1968 Corvette: Service Bulletin: Cracking of the Plenum at the Right Hood Latch Plate

Source: Chevrolet Dealer Service Technical Bulletin

Bulletin No: 68-T-68

Date: Nov. 11, 1968

RIGHT HOOD LATCH REINFORCEMENT PLATE INSTALLATION
1968 CORVETTE

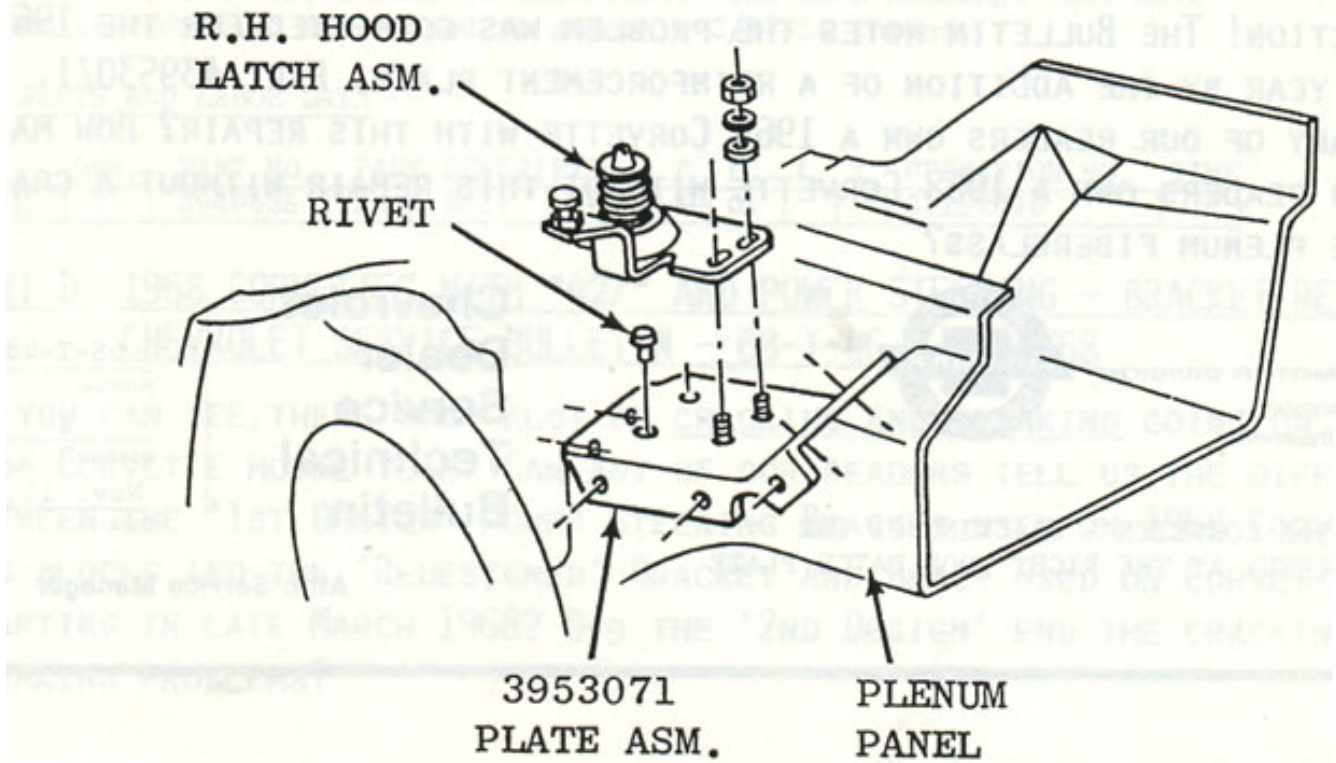
Cracking of the fiber glass plenum in the area of the right hood latch may be experienced on some 1968 Corvettes. This cracking is due to the manufacturing process of the plenum causing a glass rich condition in this area. This condition was corrected at the start of the 1969 production by the addition of a reinforcement plate to the area.

Whenever this cracking condition is encountered in the field, it may be corrected by riveting a reinforcement plate Part No. 3953071 to the outer surface of the plenum as outlined under Service Procedure.

1. Remove right hood latch assembly from the plenum panel and remove cowl vent grille.
2. Drill out two rivets retaining existing stud plate to plenum using a 7/32" dia. drill bit. Remove stud plate through cowl vent opening.
3. Position reinforcement plate on plenum as shown in sketch and drill seven (7) holes 7/32" dia. at hole locations in plate. The two (2) outboard holes are not accessible for drilling.
4. Attach the reinforcement plate to the plenum using 3/16" x 5/8" "Pop" Rivets.
5. Install and adjust right hood latch assembly as outlined in the August 1968 issue of "Chevrolet Service News." Install cowl vent grille.
